Technical BULLETIN

SAFETY RECALL

CERTAIN 2019 YZFR3AK (YZF-R3 ABS) MODELS FACTORY MODIFICATION CAMPAIGN – Front Brake Hose Touches Horn Wire

Brake Hose Inspection

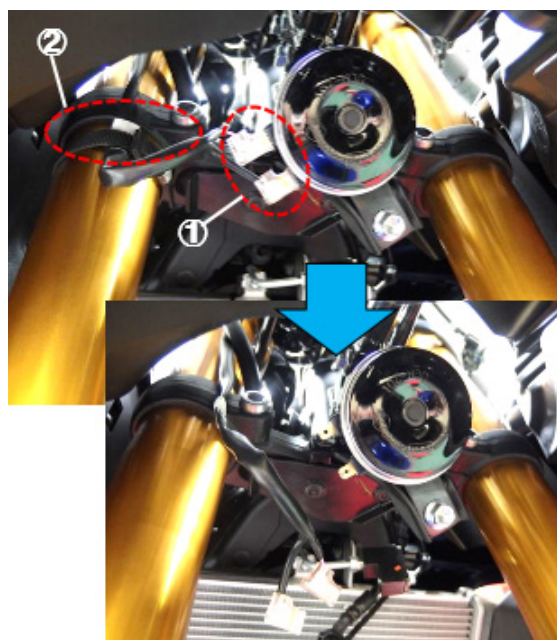
1. Remove the horn lead wire connectors (1) from the horn.
2. Remove the horn lead wire clamp (2) from the front fork. The clamp will be reused.

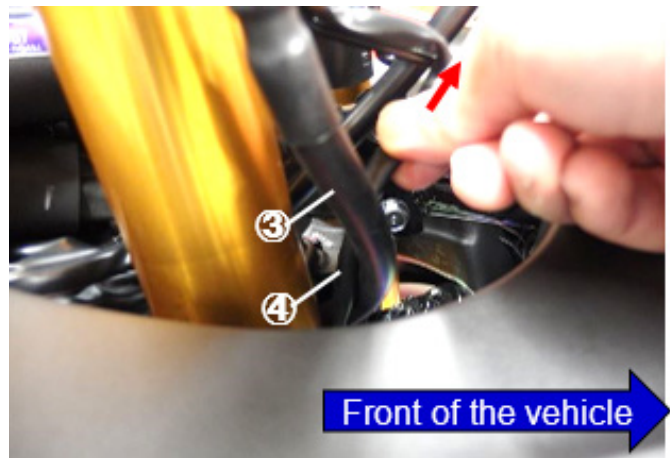
3. Pull up the horn lead wire (4), which is located behind the front brake hose (3).

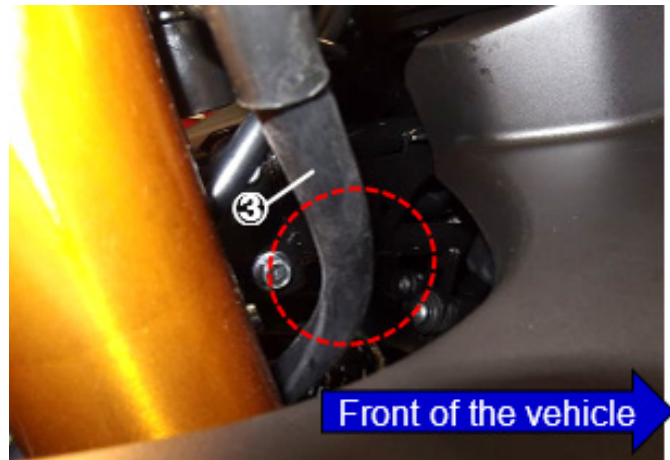
4. Check the hose protector (3) for wear or damage in the vicinity where the horn lead wire was located.

If there is wear or damage, refer to the service manual (p/n LIT-11616-32-26) to replace the brake hose before beginning this modification. Remember to check for wear due to a missing brake holder according to M2020-002R at the same time.

Changing the Lead Wire Routing

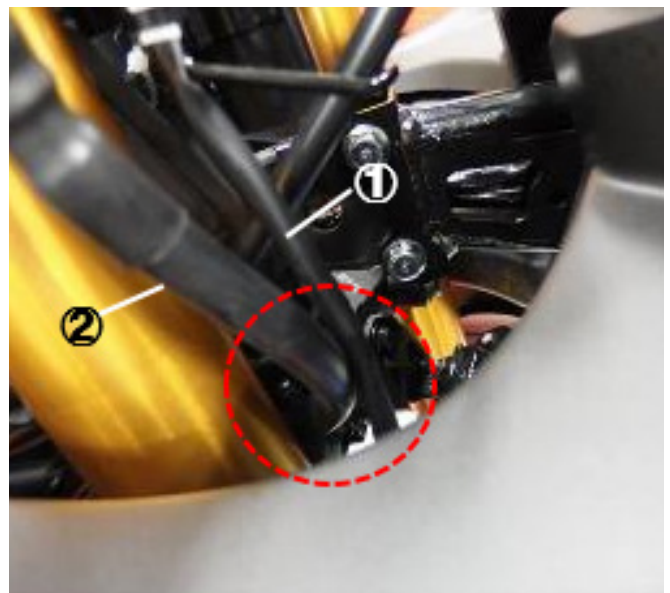
Yamaha Motor Corporation, U.S.A. has decided that a defect which relates to motor vehicle safety exists in certain 2019 YZFR3AK (YZF-R3 ABS) motorcycles. In affected units, the front brake hose touches the horn lead wire when turning the handlebar from left to right. As a result, this could cause wear to the front brake hose, causing it to leak brake fluid and affect braking ability, which could cause a crash with injury or death.

1. Route the horn lead (1) in front of the front brake hose (2).
